SUBJECT: WOLF CREEK GENERATING STATION - AMENDMENT NO. 23 TO FACILITY
OPERATING LICENSE NO. NPF-42 (TAC NO. 68648)

SUBJECT: WOLF CREEK GENERATING STATION - AMENDMENT NO. 23 TO FACILITY
OPERATING LICENSE NO. NPF-42 (TAC NO. 68648)

Amendment No. 23
License No. NPF-42

ATTACHMENT TO LICENSE AMENDMENT NO. 23

FIGURE 3.2-3

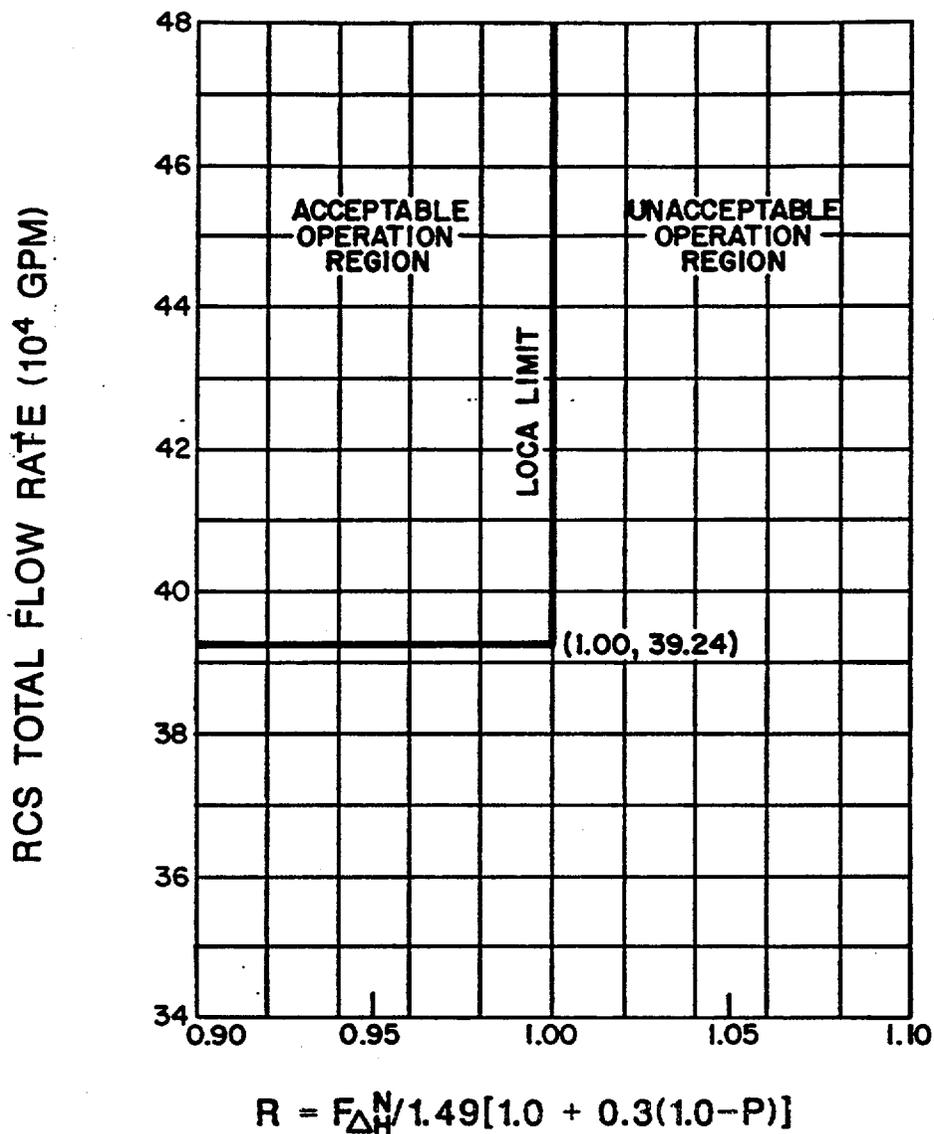
3.2.3 The combination of indicated Reactor Coolant System (RCS) total flow rate and R shall be maintained within the region of allowable operation shown on Figure 3.2-3 for four loop operation.

c. $F_{\Delta H}^N$ = Measured values of $F_{\Delta H}^N$ obtained by using the movable incore detectors to obtain a power distribution map. The measured values of $F_{\Delta H}^N$ shall be used to calculate R since Figure 3.2-3 includes measurement uncertainties of 2.5% for flow and 4% for incore measurement of $F_{\Delta H}^N$.

MEASUREMENT UNCERTAINTIES OF 2.5% FOR FLOW
 AND 4.0% FOR INCORE MEASUREMENT OF $F_{\Delta H}^N$
 ARE INCLUDED IN THIS FIGURE

Based on the information presented in the licensee's letter dated June 24, 1988, the staff has concluded that the licensee's proposed changes to Technical Specifications 3.2.3, 3.1.2.5, 3.1.2.6, 3.5.1, 3.5.5, 3.10.4, Figure 3.2-3, Table 2.2-1 and corresponding Bases are therefore acceptable.

When RCS flow rate and $F_{\Delta H}^N$ are measured, no additional allowances are necessary prior to comparison with the limits of Figure 3.2-3. Measurement errors of 2.5% for RCS total flow rate and 4% for $F_{\Delta H}^N$ have been allowed for in determination of the design DNBR value.
